Docket: Southern California Edison Company, San Onofre Nuclear Generating Station,
 Units 2 and 3, Docket Nos. 50-361-CAL & 50-362-CAL

Re: Seventh Notification of Responses to RAIs

Subject: **Docket No. 50-361
Response to Request for Additional Information (RAI 11), Revision 1
Regarding Confirmatory Action Letter Response
(TAC No. ME 9727)
San Onofre Nuclear Generating Station, Unit 2**

Subject: **Docket No. 50-361
Response to Request for Additional Information (RAI 13), Revision 1
Regarding Confirmatory Action Letter Response
(TAC No. ME 9727)
San Onofre Nuclear Generating Station, Unit 2**

Figure 1 – Model for Estimating TTW Initiation Time

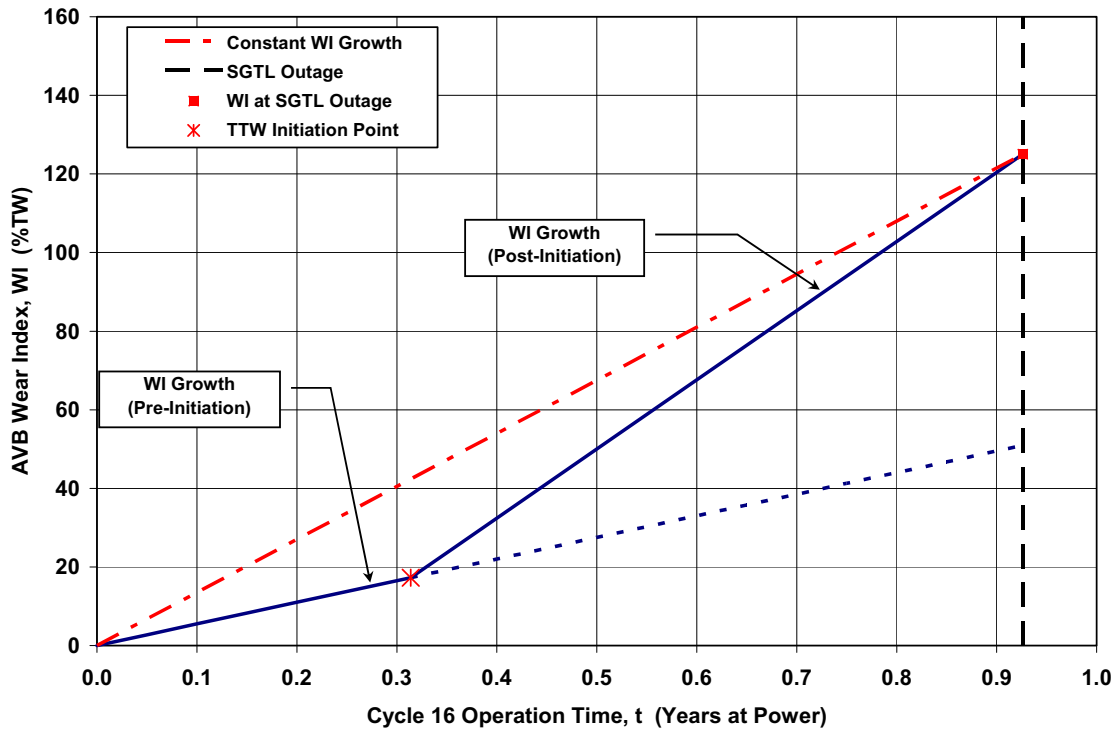
- a. Reference 4, page 3-2 defines “wear index” for a degraded tube and states that the existence of TTW and distribution of TTW depths are strongly correlated to the wear index. This is pictured in Figures 4-4 in terms of TTW initiation. This figure shows that TTW is not expected to have initiated until a threshold value of wear index is reached. This threshold value varies from tube to tube according to a cumulative probability distribution shown in the figure. This figure illustrates that TTW is not expected to have initiated until sometime after BOC 16. This suggests that the observed TTW depth at EOC 16 developed over a smaller time interval than the 0.926 years assumed in the analysis.

As shown in Figure 1, the growth in the wear index occurs in two stages: pre-initiation and post initiation. The initiation-time model for TTW uses a wear index based only on tube to AVB wear in the upper supports (B03 through B10). This model's wear index (WI) starts to increase at the beginning of the cycle. The basis for this approach was developed from the Unit 3 wear data as follows:

The predicted TTW initiation time is calculated by simulating two-stage growth in the WI. The initiation model is constrained to the end state for the calculated wear index from the NDE results. The slopes for the growth in the WI are also constrained to keep the two-stage process bounded by the constant WI growth case illustrated in Figure 1.
